Re: ACTION RE: APPROVAL SITE PLAN AND DESIGN REVIEW FOR GREEN BAY AREA PUBLIC SCHOOL DISTRICT WEBSTER ELEMENTARY SCHOOL AT 2101 S WEBSTER AVENUE

WEBSTER ELEMENTARY ADDITION AND REMODEL GREEN BAY AREA PUBLIC SCHOOL DISTRICT CITY OF GREEN BAY, BROWN COUNTY, WISCONSIN

Site Plan & Design Review – Staff Comments

Site: 2101 S Webster Avenue (Parcel AL-58)
Development: Green Bay Area Public Schools (GBAPS) - Webster Elementary School
Developer Representatives: GBAPS – Michael Strangel – Executive Director of Facilities and Related Services
 Somerville – Duane Grove – Project Architect
 Robert E. Lee & Associates, Inc. – Patrick H. Kuehl, P.E. – Civil/Municipal Project Manager

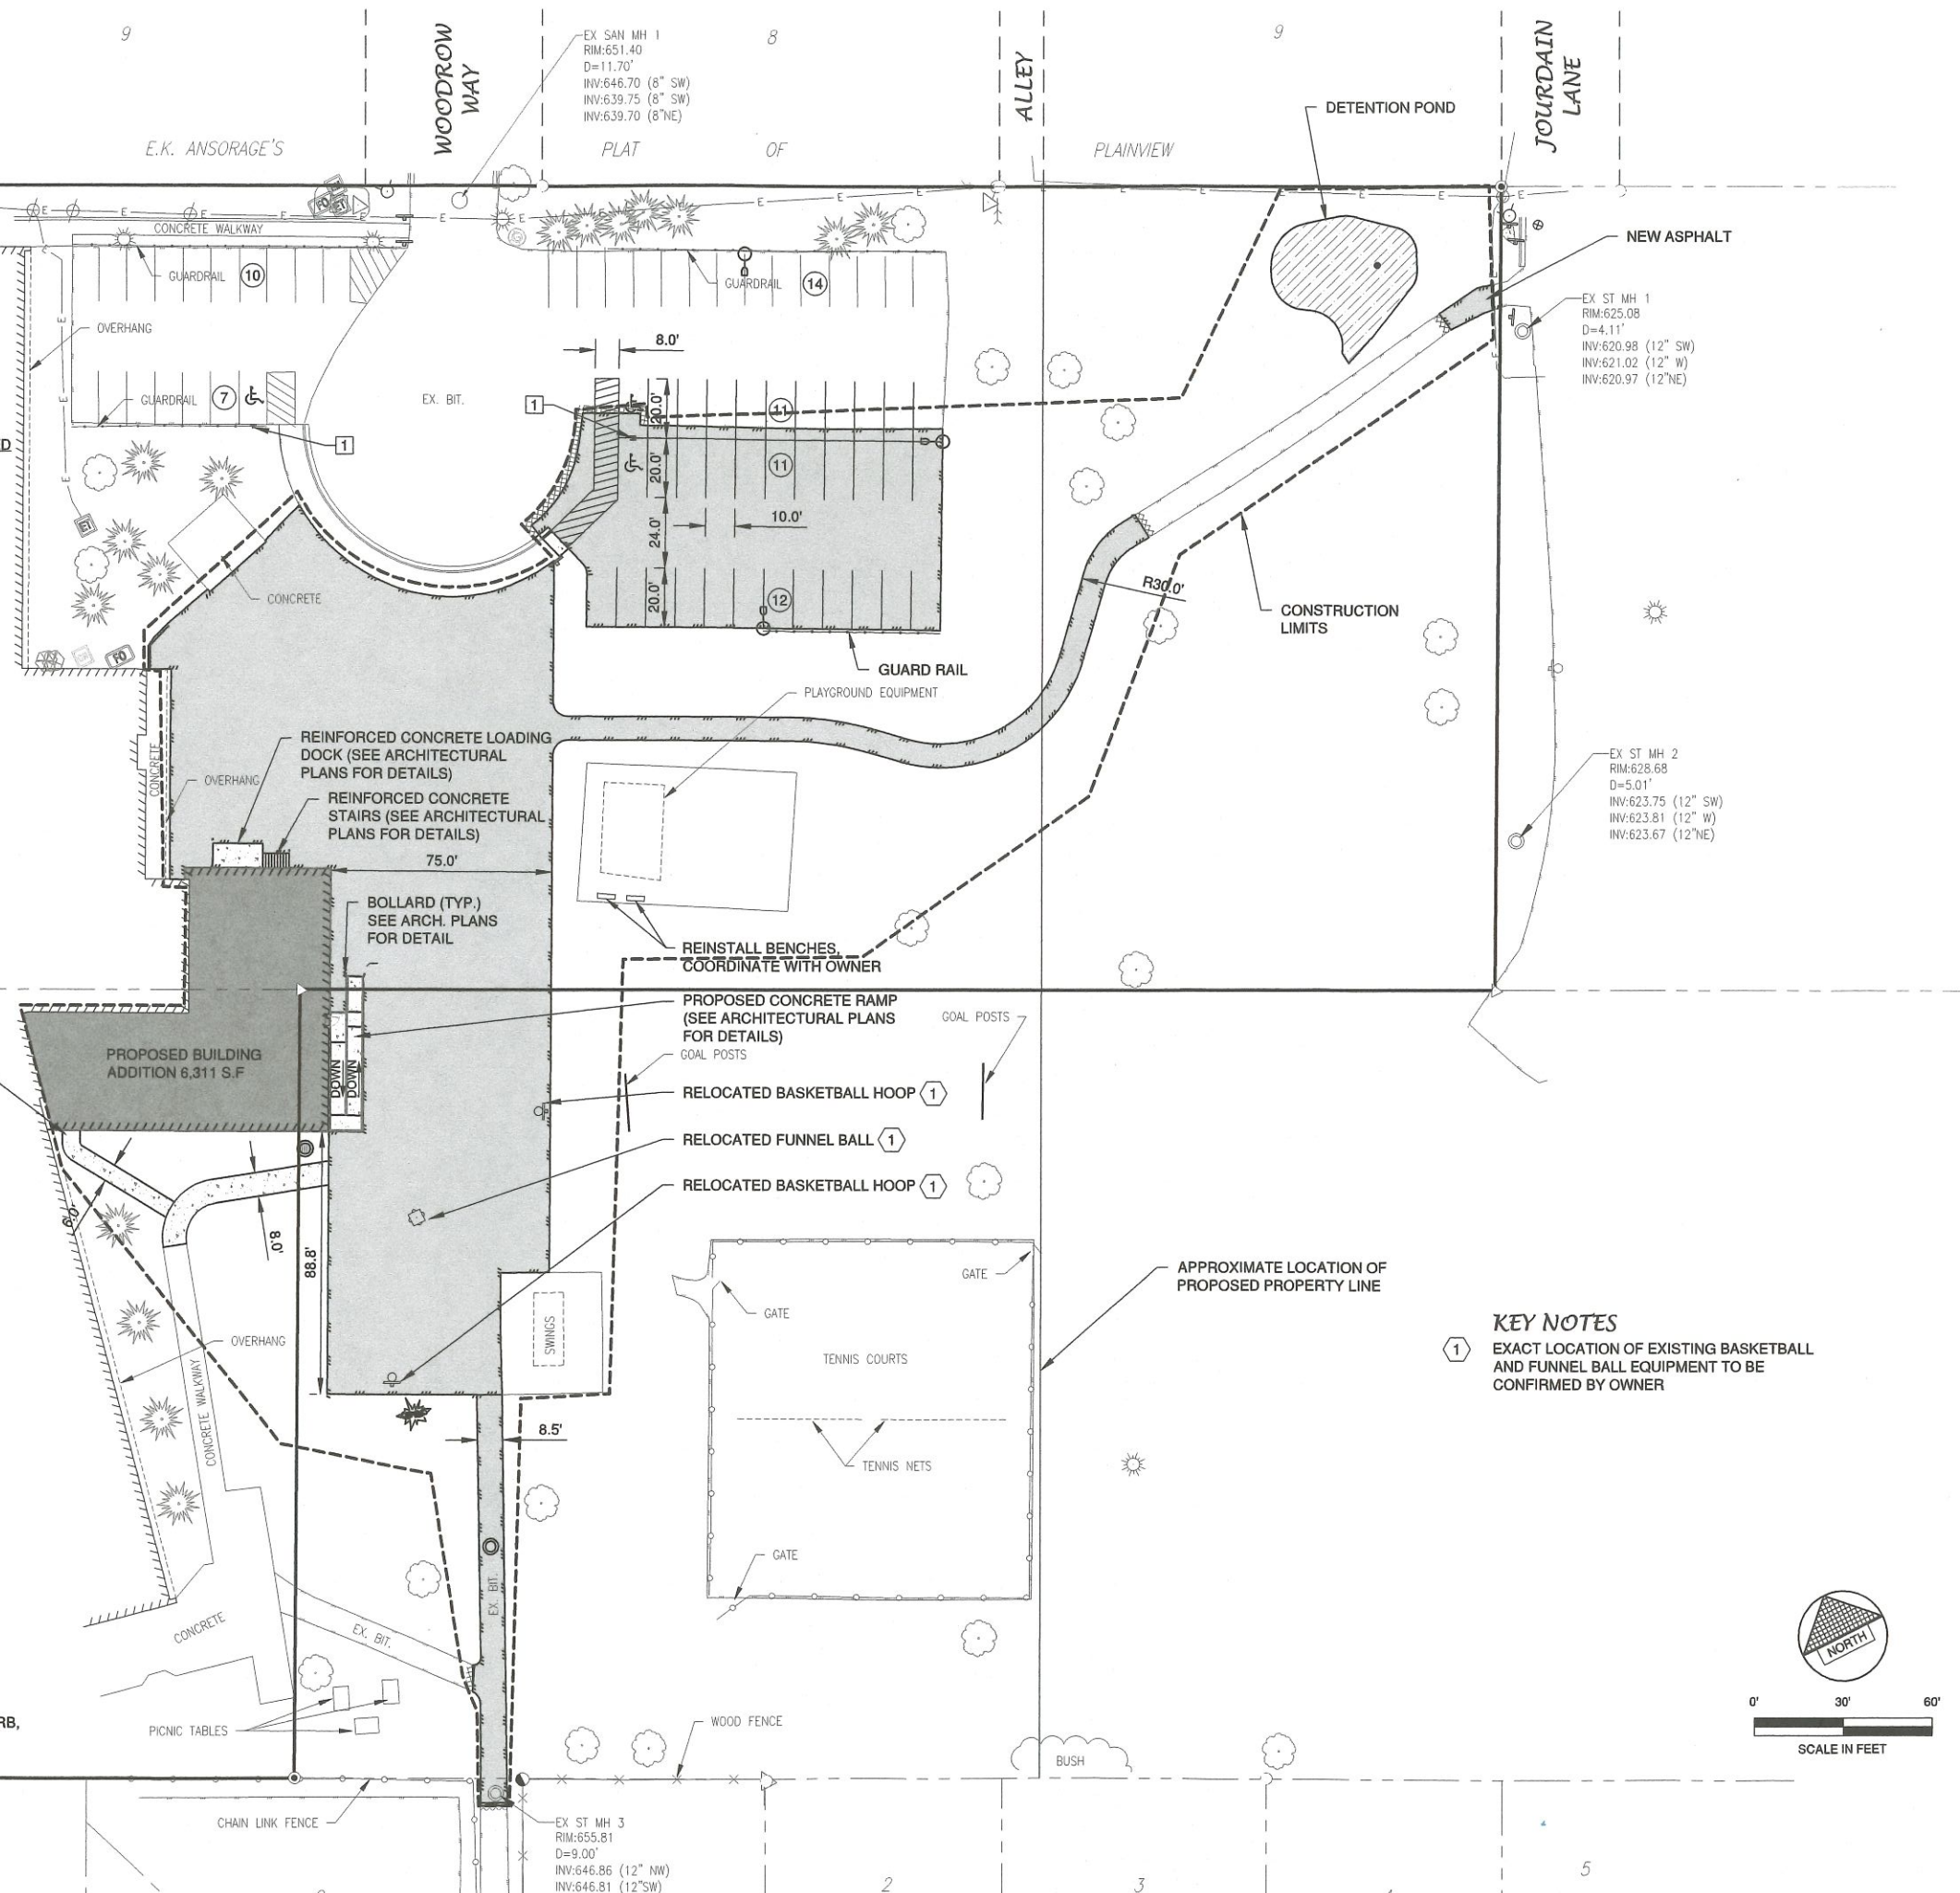
- Parks, Recreation, and Forestry Department review:
 - Approval should be contingent on land swap.
 - Woody vegetation northeast of the parking lot to deter sledding and screen parking lot from view.
 - Suggests the dry pond be planted with vegetation.
